Company	Trenz Electronic GmbH
PCN Number	PCN-20190311
Title	TE0725LP-01 SPI Flash Change
Subject	BOM change
Issue Date	20190311

This change affects all TE0725LP modules of revision 01 : TE0725LP-01

Locate Flash (U7) on backside of PCB:

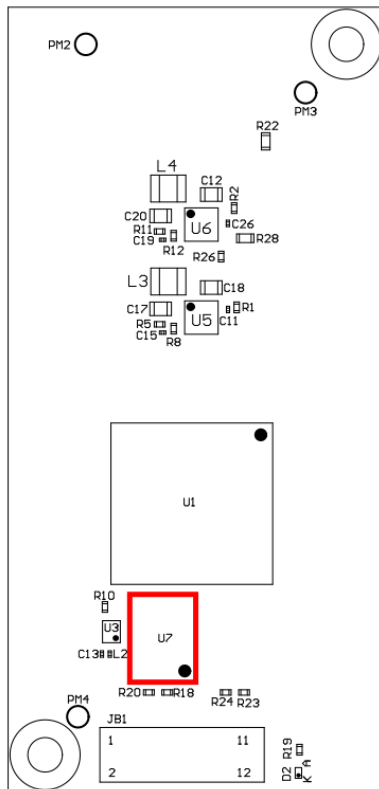
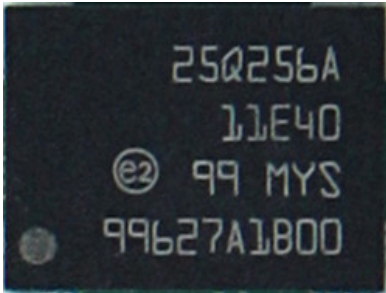
#1 Change SPI Flash from N25Q256A11E1240E to MT25QU512ABB8E12-0SIT

Reason: N25Q256A11E1240E became obsolete.

Impact: Size changed from 256 MBit to 512 MBit. JEDEC ID changed from BB19h to BB20h both with manufacturer ID: 20h.

old	new
N25Q256A11E1240E	MT25QU512ABB8E12-0SIT
